RE: Drainage Conformance Letter
Lot 4, the Shops Filing 1 at Meridian Ranch
PCD File No. PPR-18-033

LOT 4 - THE SHOPS FILING 1
FINAL DRAINAGE PLAN
FIGURE X

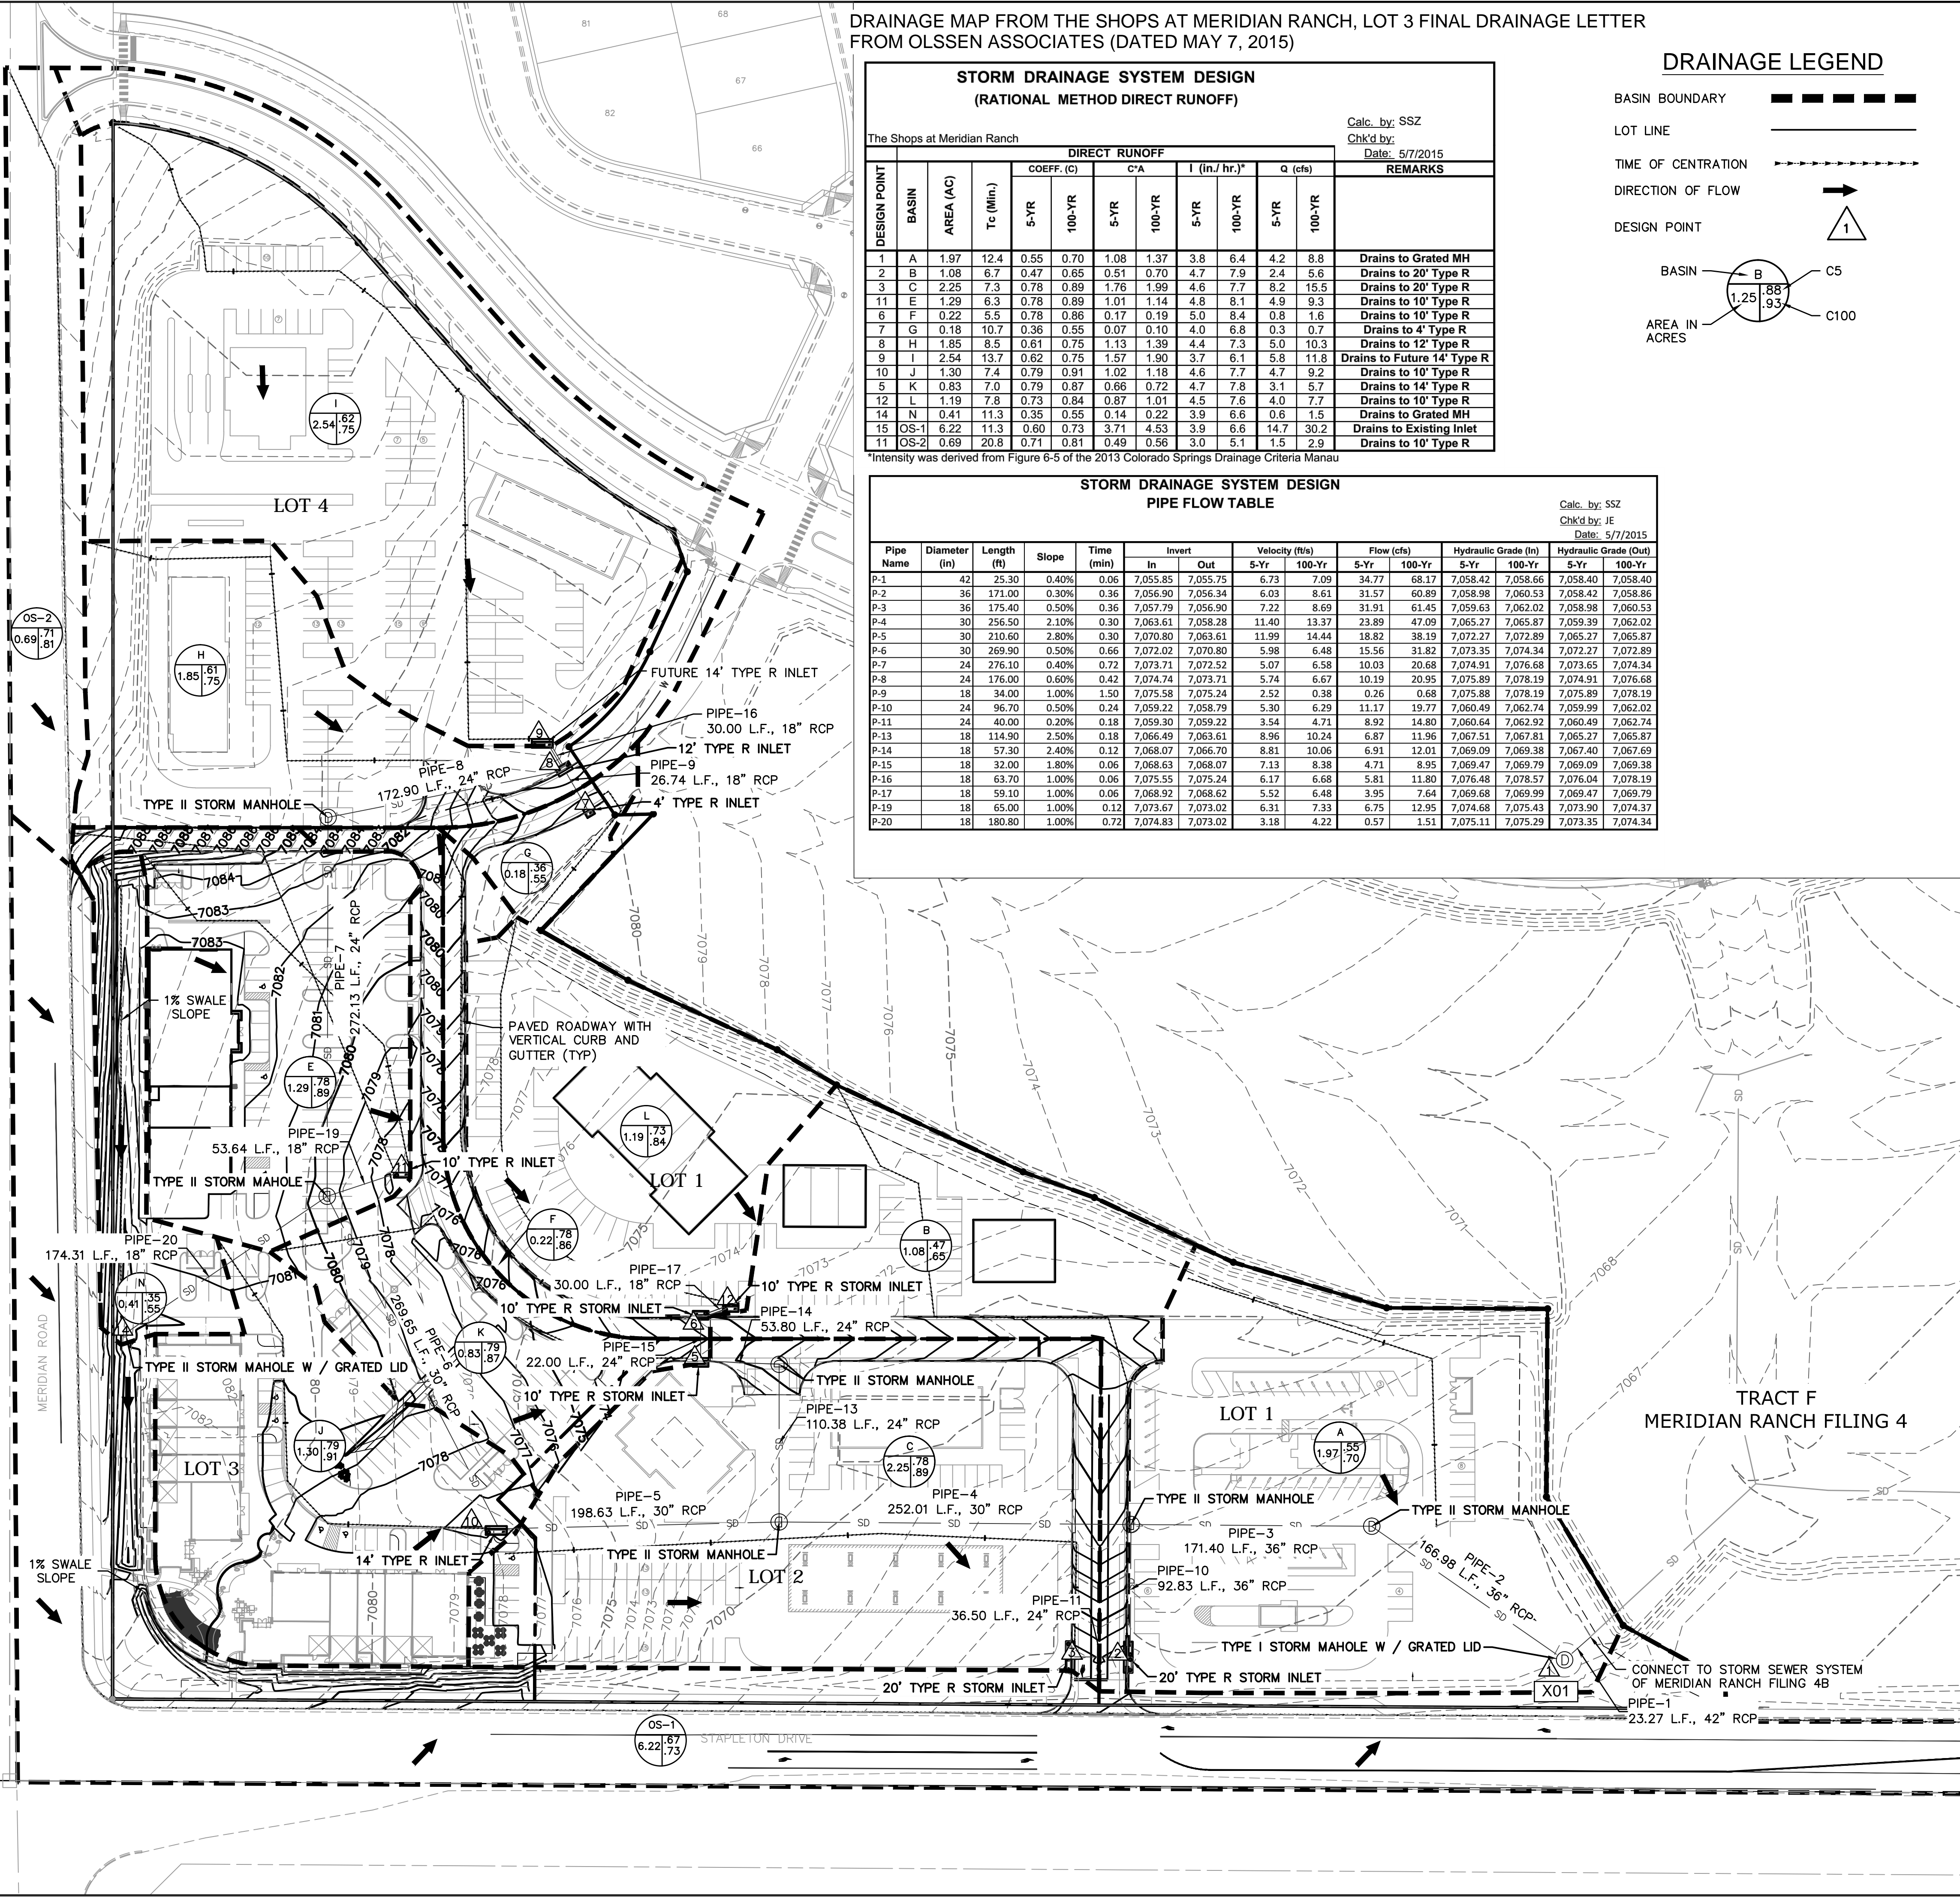
Show your flow path for each sub-basin on the drainage map. The lengths appear to be incorrect.

Show your flow path for each sub-basin on the drainage map. The lengths appear to be incorrect.
